UNITED STATES PATENT AND TRADEMARK OFFICE

Office Action Summary

10/813,328

DETAILED ACTION

Fig 1

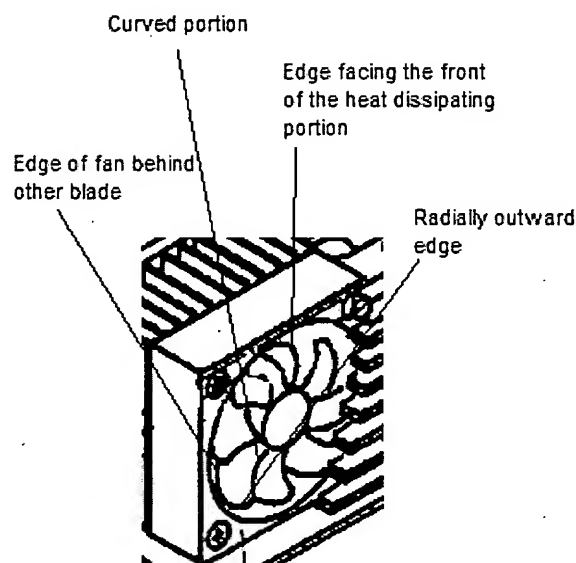
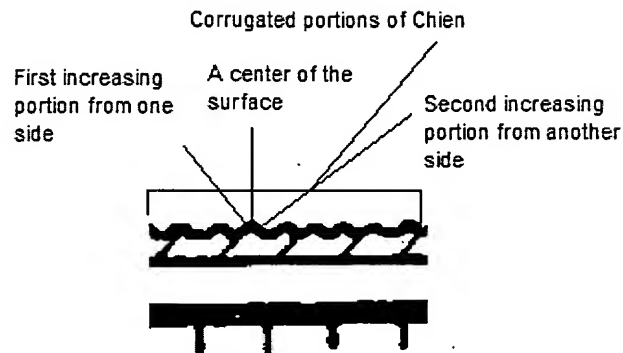
With respect to the applicants' remarks to claim 1 that, "one skilled in the art would not interpret the Chien fan (i.e., fan 62 of Fig. 5) as teaching the impeller structure of amended claim 1", the examiner respectfully disagrees. As illustrated in the present office action Fig 1 below (An exploded view of fan 62), the fan blades have an edge facing the front of the heat dissipating portion. The examiner further submits that the blades must be sloping since the blades overlap (See edge of fan behind other blade,

the examiner notes that if the blades did not slope they would interfere with each other).

Finally the blades extend from a rotating center radially outward.

Fig 3

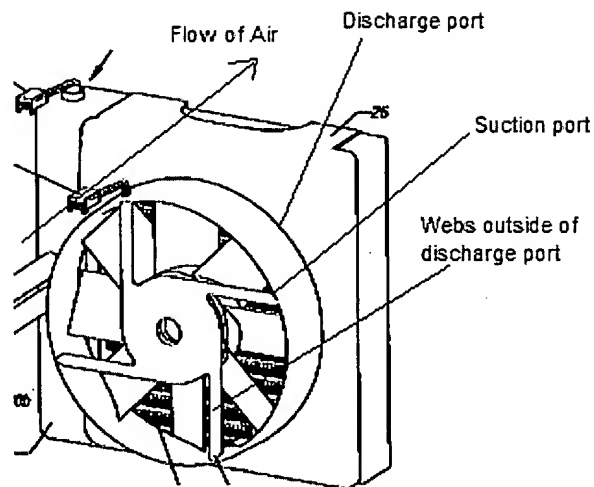
With respect to the applicants' remarks to claim 3 that, "the webs illustrated in the Gwin patent are clearly disposed within the discharge port, rather than outside the discharge port as required", the examiner respectfully disagrees. As illustrated in the present office action Fig 3 below, that similar to the present invention, the structure of Gwin has a suction port and a discharge port. The examiner respectfully notes that the discharge port is directly adjacent the heat exchanger (36 - that is, the discharge port abuts against the heat exchanger) and thus the webs (Also denoted 14) are located outside of the discharge port as required in claim 3.
